Consultation on proposed changes to the Torrington Place / Tavistock Place corridor

This response to the consultation on the above proposal from Camden Council is from Camden Cycling Campaign, the local borough group of London Cycling Campaign. We represent the interests of cyclists living or working in the Camden and aim to expand the opportunities for all to cycle safely in the borough. We have discussed this consultation by with our committee, by email and online (using Cyclescape).

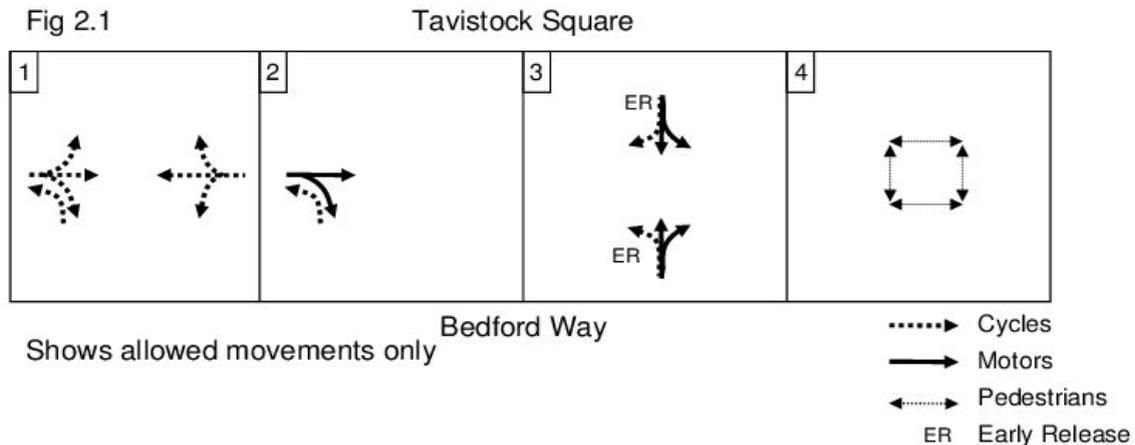
Figure 2.1 proposes an extra signal stage in which westbound cycles are held while eastbound motors turn right. Although this will remove a conflict, it doesn't provide right turns for cycles.

We note from Figure 2.2 that in the westbound option, cycles on the corridor are given a separate stage in the signals which would enable them to make all available turns in a single stage. Tables 2.1 and 2.2 show that 57.9% and 79.1% Max Degree of Saturation (DoS) for the east and westbound options respectively.

We therefore suggest that (in the eastbound option) cycles on the corridor are given a separate stage in the signals which would enable them to make all available turns in a single stage.

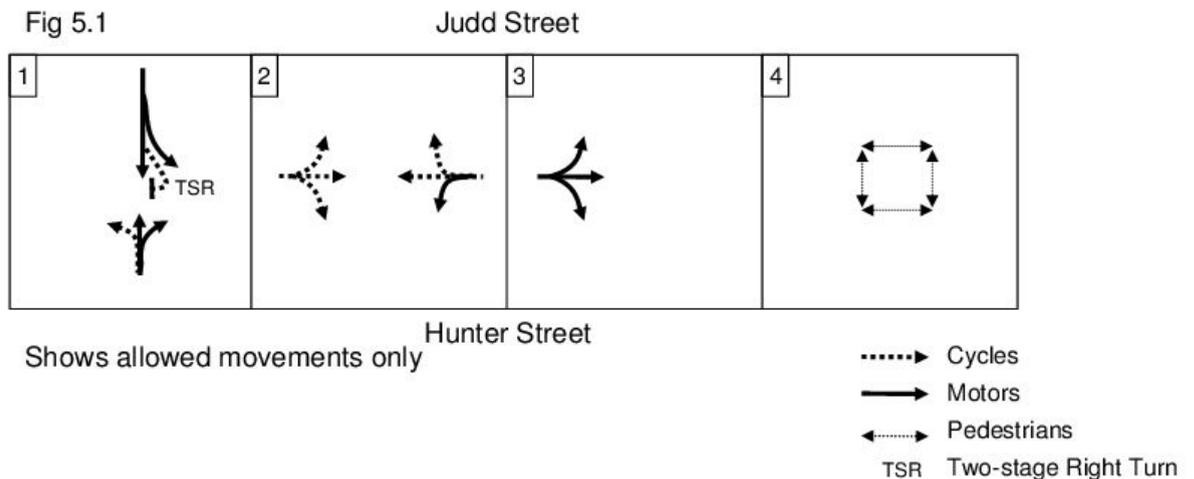
Figure 5.1 indicates that all westbound traffic will now be allowed to turn right, which caters for cycles on CS6 needing to turn right into Judd Street. However, we would prefer that only cycles be allowed to make this manoeuvre (i.e. 'Left Turn Only — Except Cycles')³. This would enable the signalling solution that we suggested in our response to the 2016 consultation and we will outline below. Permitted turns for motors would be as now so would not need re-modelling.

In stage 2 of Figure 5.1 all vehicles exit Tavistock Place (west) eastbound and can make all turns and (as is the current situation) straight ahead cycles are at risk of left hook. Since the cycles are in a separated lane, they can be provided with a separate signal stage. We therefore suggest the following stages:

- Stage 1 as in Figure 5.1 but with the addition of a two-stage right turn for cycles southbound on Judd Street turning west into Tavistock Place;
- Stage 2: east and westbound cycles run together with the westbound motors (motors turning left and cycles making all movements);
- Stage 3: eastbound motors on Tavistock Place all movements;
- Stage 4: pedestrian all-green stage.
